4 February 2018

Senior Executive Officer,
Forward Planning Section,
Land Use, Planning and Transportation,
South Dublin County Council,
County Hall,
Tallaght,
Dublin 24

Submission on Proposed Celbridge Link Road

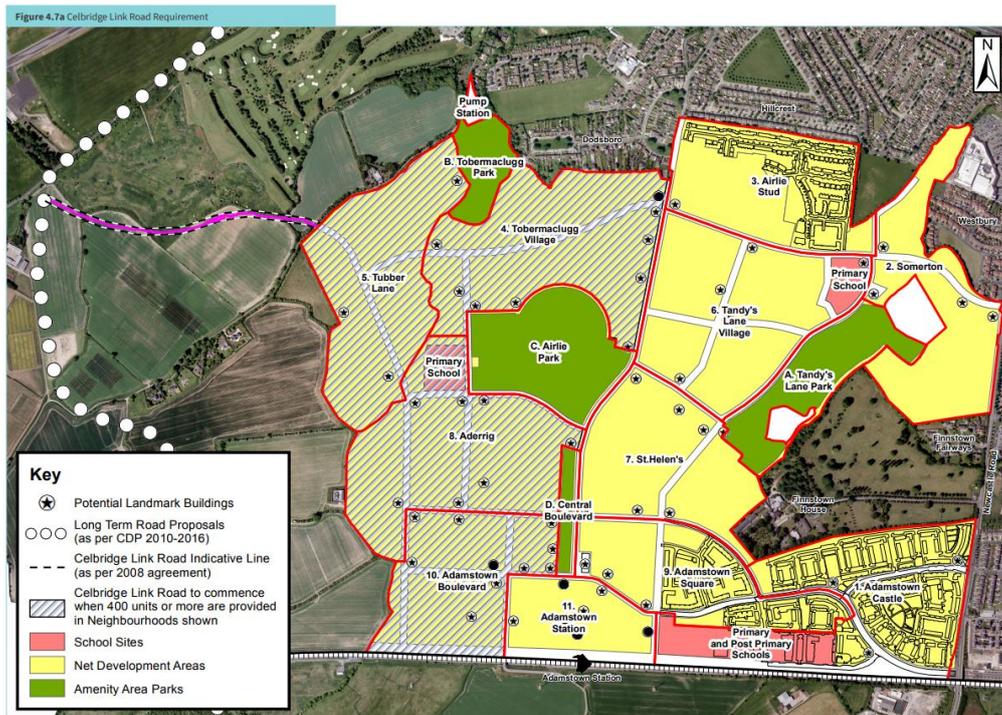
Due to the expected extra volume on the R403 as the populations of Celbridge and Adamstown grow, Celbridge Community Council expects that the morning peak hour congestion on the R403 (circled in pink in this congestion map from the [BusConnects Brochure](#)²) will be pushed from Moderate to Significant / Severe sooner than 2032. This will cause yet another delay for bus users and motorists on top of the numerous existing delays.

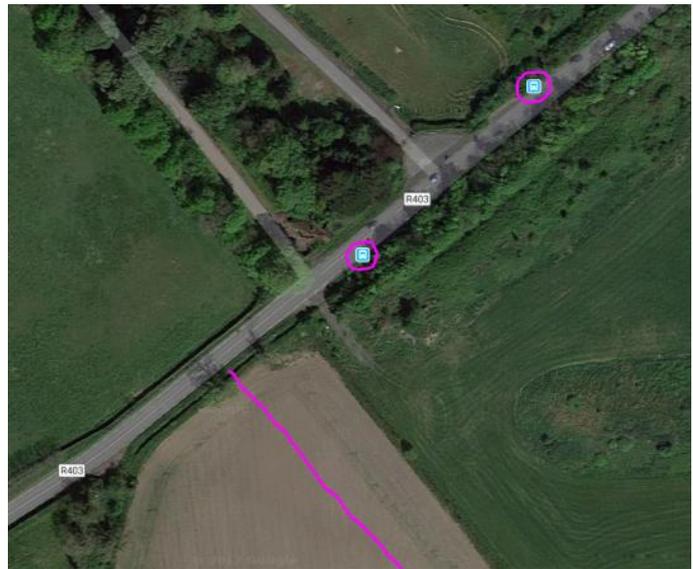
The proposed Celbridge Link Road (marked in pink with dashed outline on top left) forms part of a much bigger plan as can be seen in this map from the revised [Phasing and Implementation](#)³ document for the Adamstown SDZ.

The proposed Western Dublin Orbital Route (a long term high capacity road proposal to connect the N7 to Junction 5 on the N4 via Backweston) can be seen to the west of the proposed Celbridge Link Road.

If, as part of the proposed Western Dublin Orbital Route, the R403 between Backweston and N4 Junction 5 is upgraded then a number of the concerns raised in this submission about traffic congestion between Backweston and the N4 may be resolved. However, no dependencies on the Western Dublin Orbital Route are stated so construction of the junction between the proposed Celbridge Link Road and the R403 needs to be done properly, fully expecting that the Western Dublin Orbital Route might never happen.
